RE: Presbyterian Hospital Expansion 1100 Central SE et al. Conceptual Grading and Drainage Plan Engineer's Stamp Date: 10/29/19 Hydrology File: K15D005

Based on the submittal received on 10/29/19, the Grading and Drainage Plan is approved for Site Plan for Building Permit.

Presbyterian Healthcare Services Hospital Expansion – Hydrology Resubmittal: Hydrology File: K15D005

OVERALL GRADING AND DRAINAGE PLAN

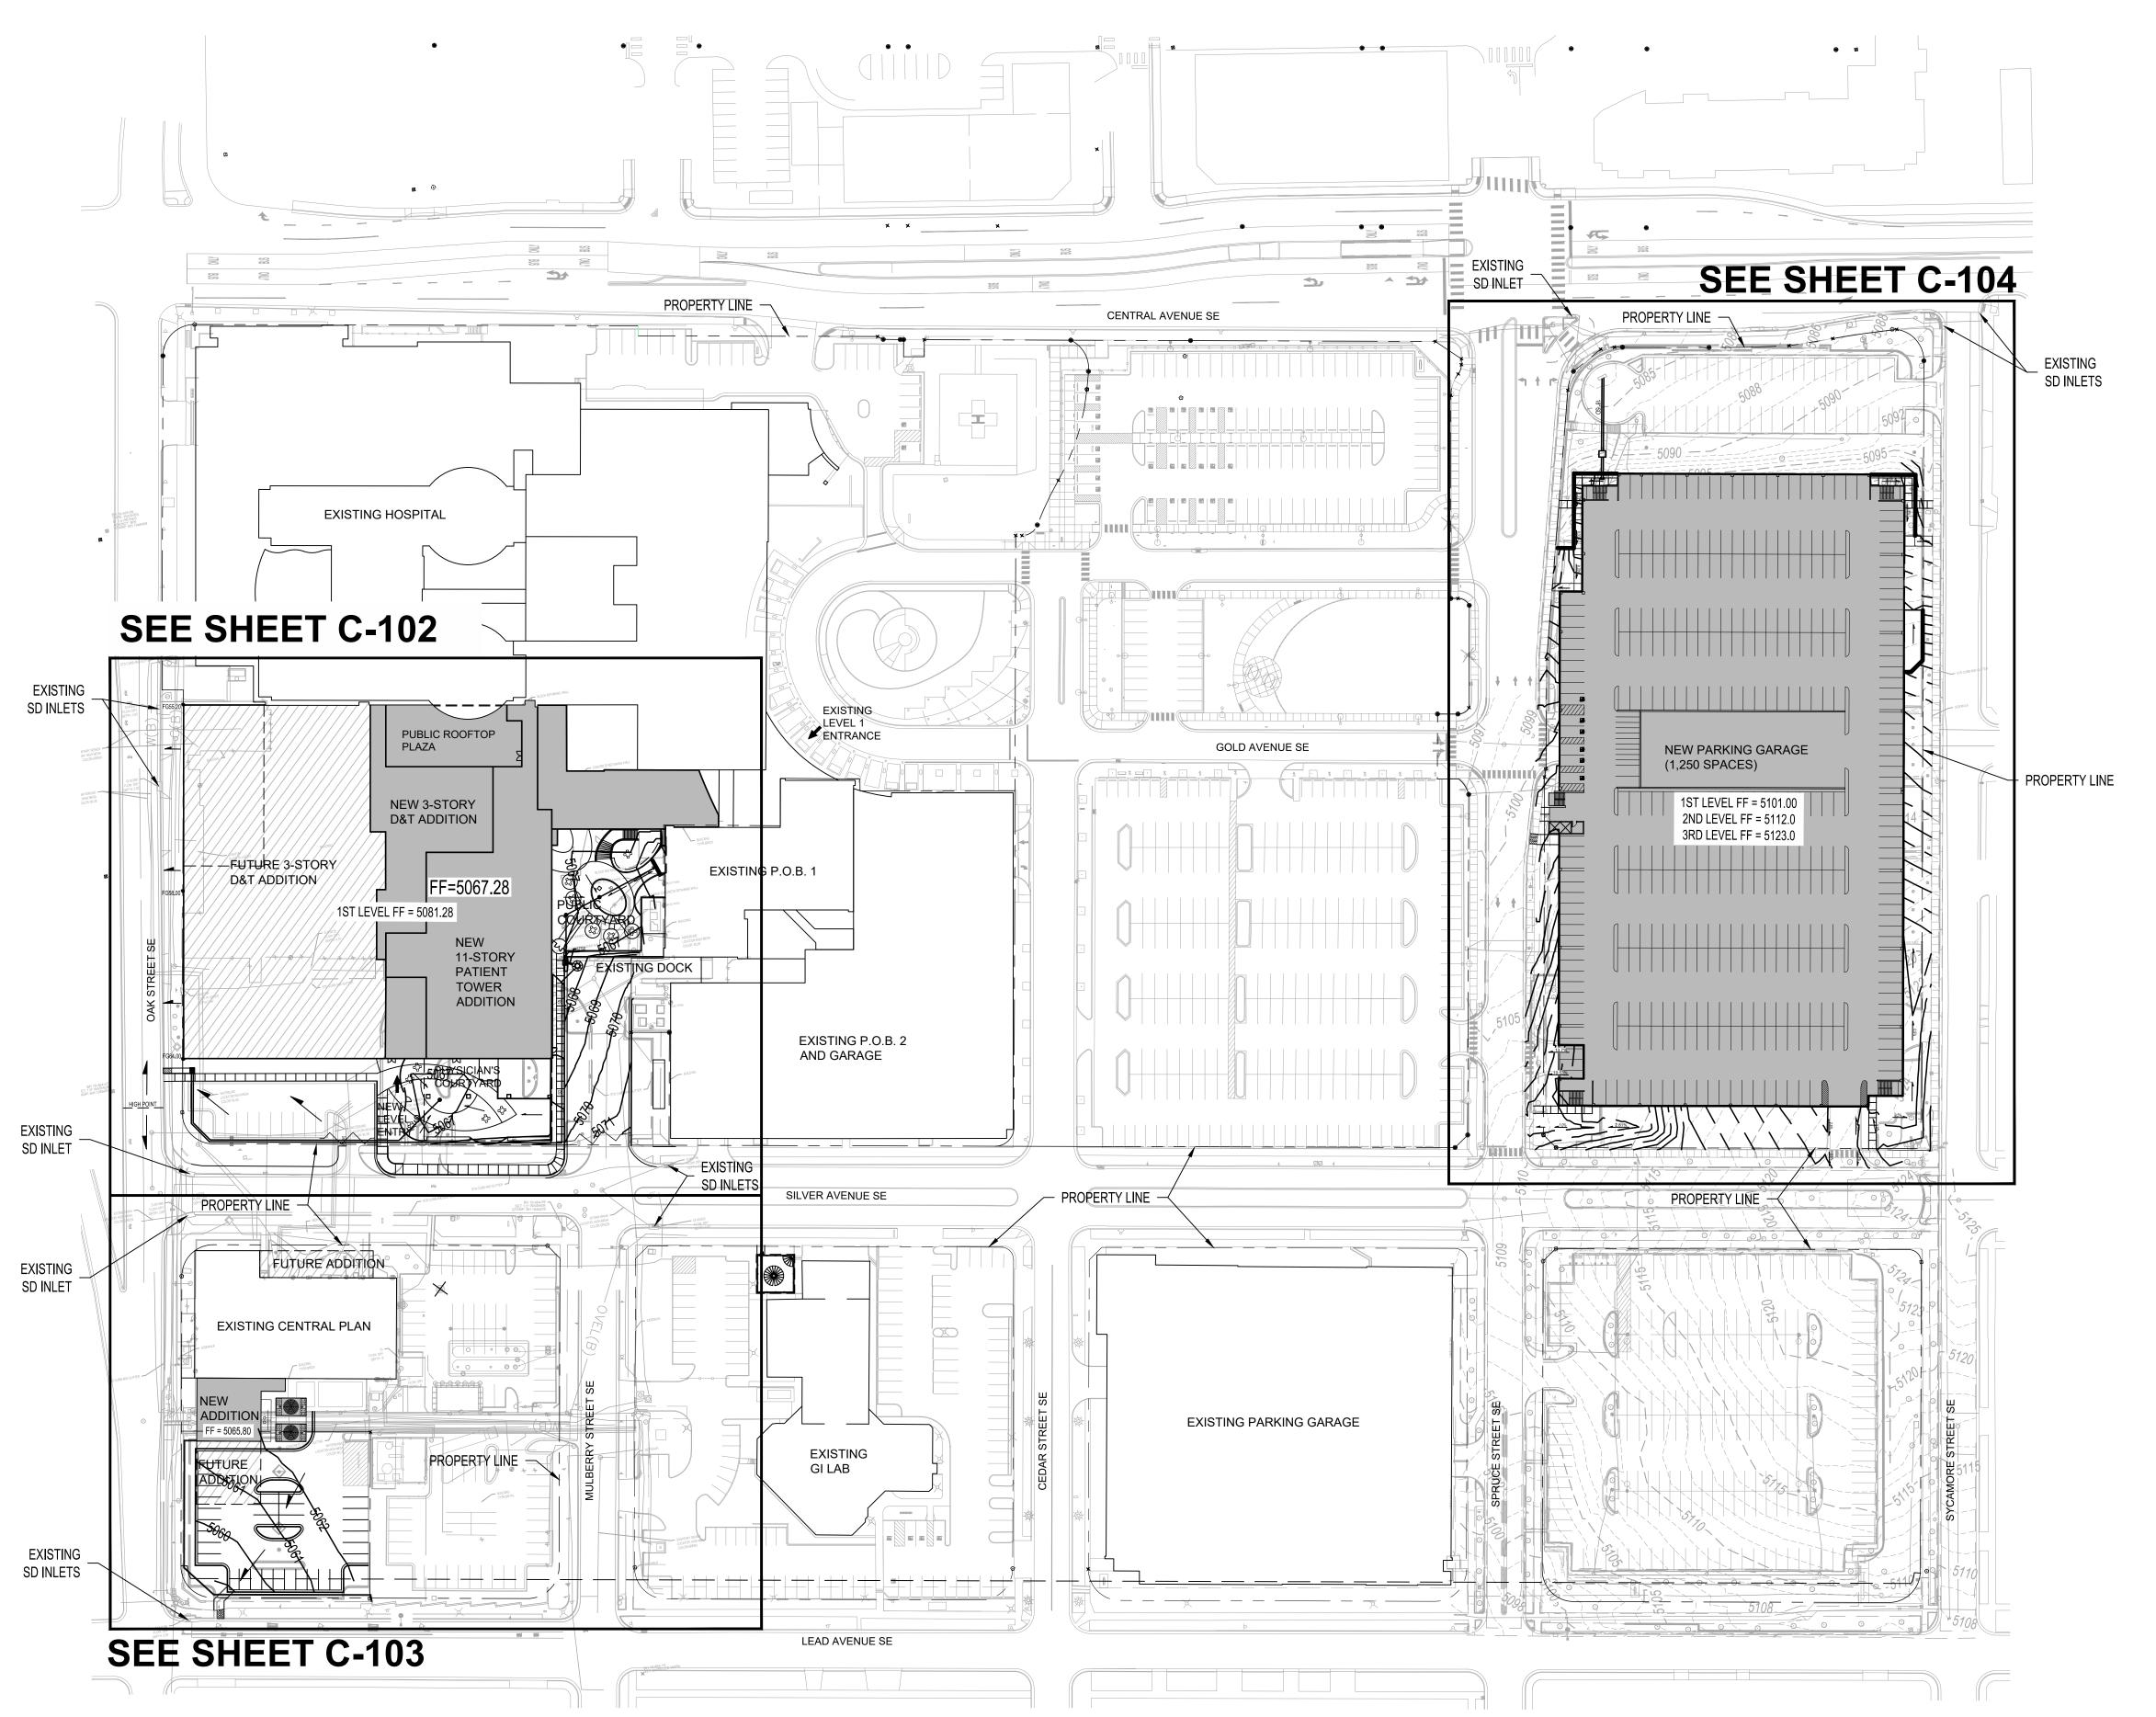
- 1. The grading plan needs to cover the full extent of the work. The north edge of the Patient Tower area is clipped. It may be easier just to make the Patient Tower area a separate viewport from the Energy Plant Response: The viewport limits will be adjusted to include the entire work area. A separate sheet for the area south of Silver Ave will also be added.

CONCEPTUAL GRADING AND DRAINAGE PLAN AREA A

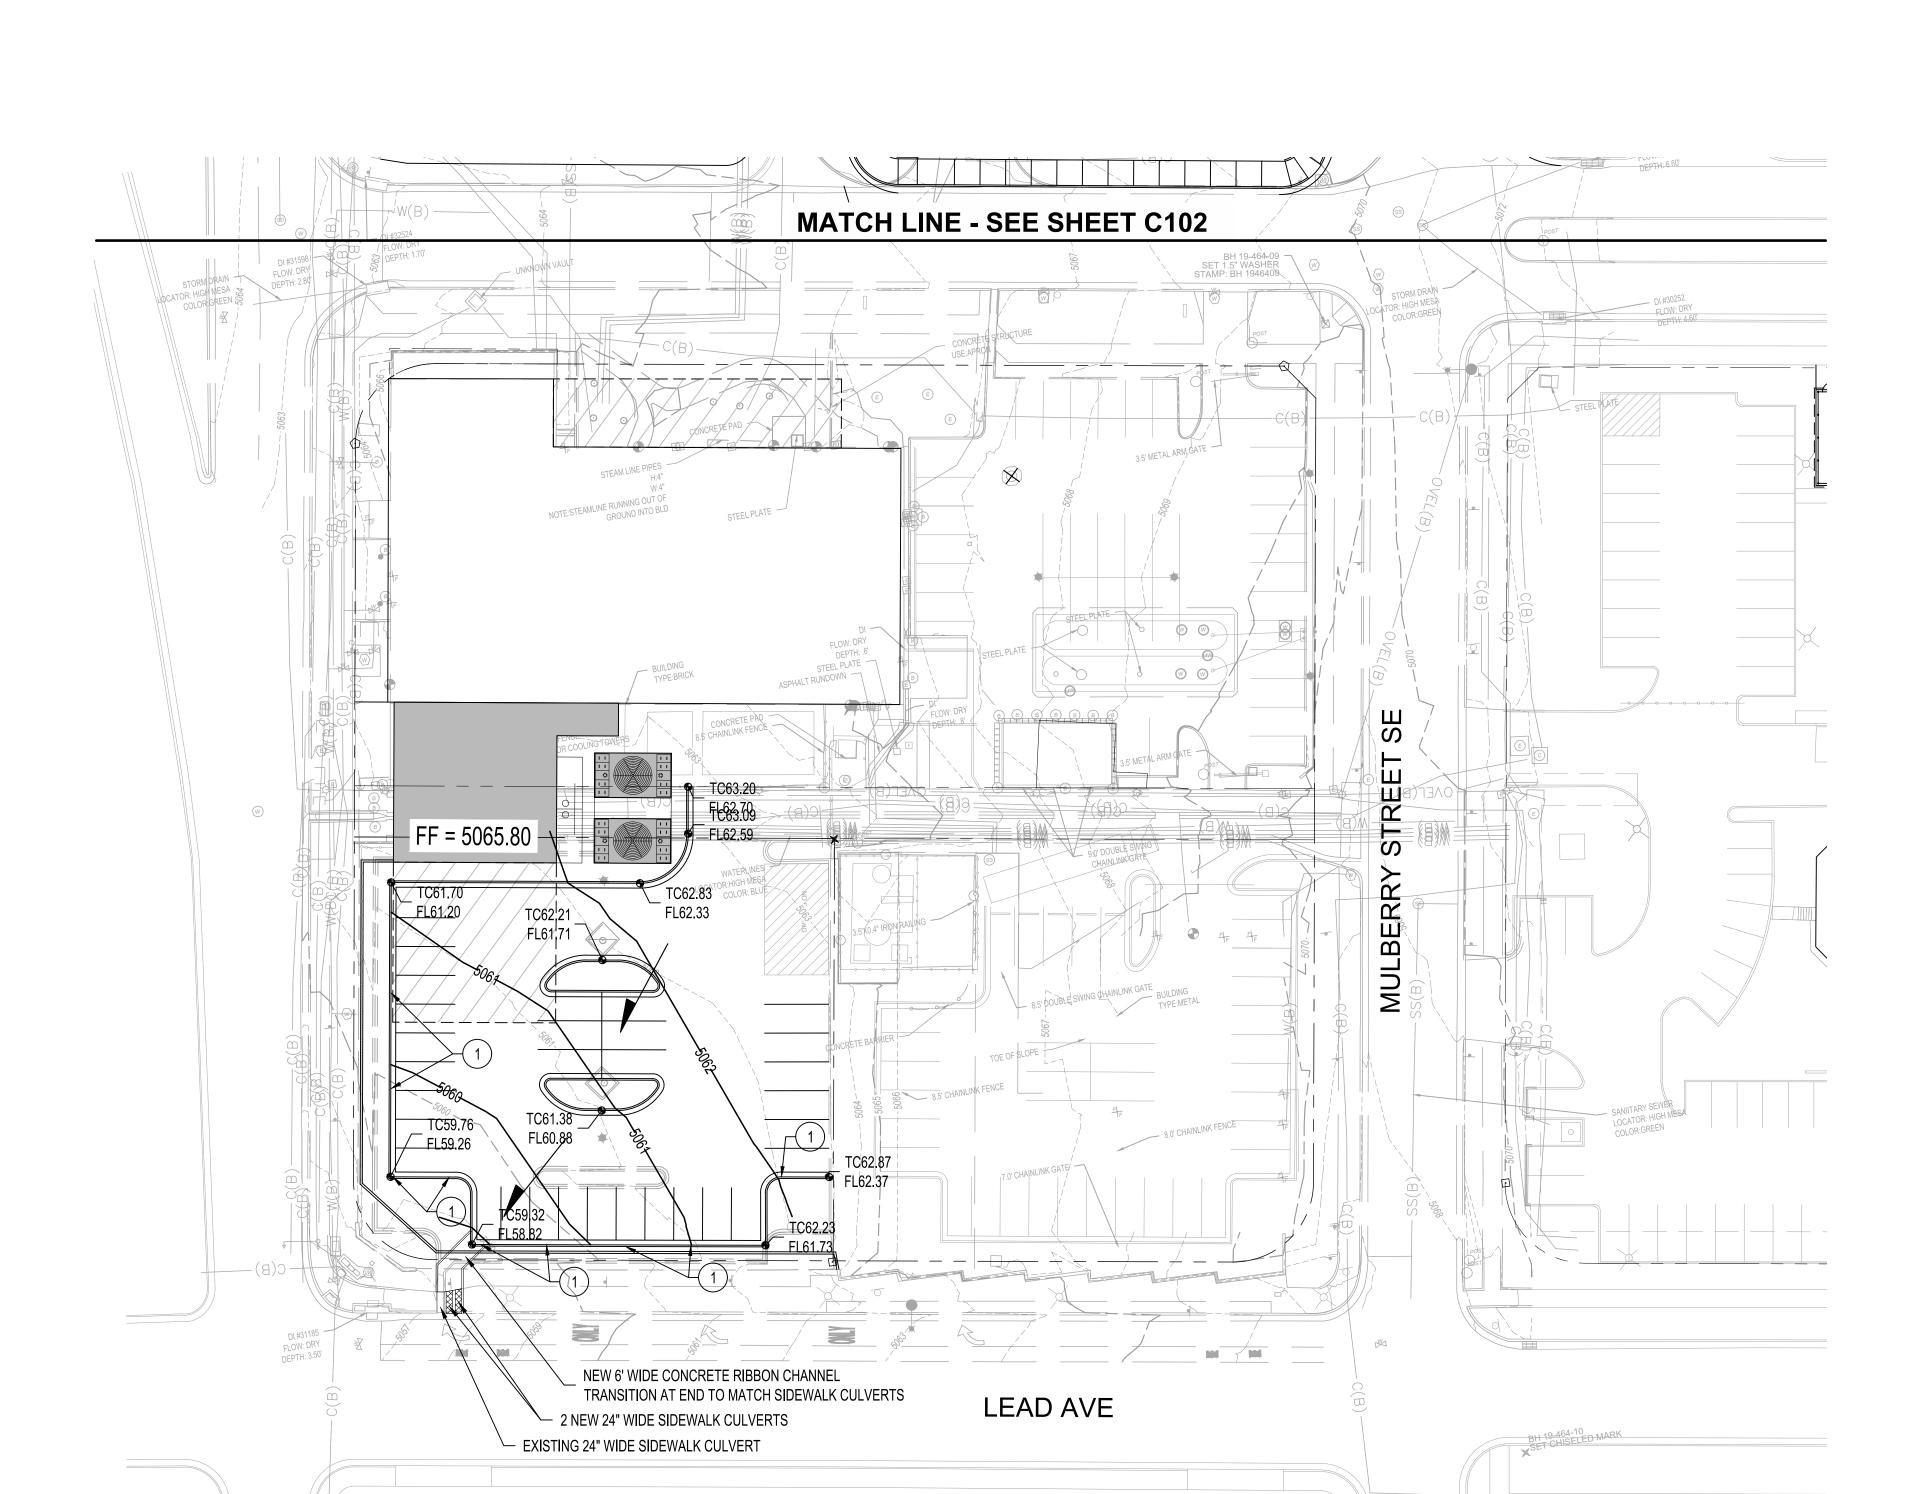
- 6. Provide the design for the lift station. Include pump curves, a section showing elevations of pump-on, pump-off, max WSE, etc..., contributing area hydrology. Where is the emergency overland path, or the extents of the ponding if the pump fails?
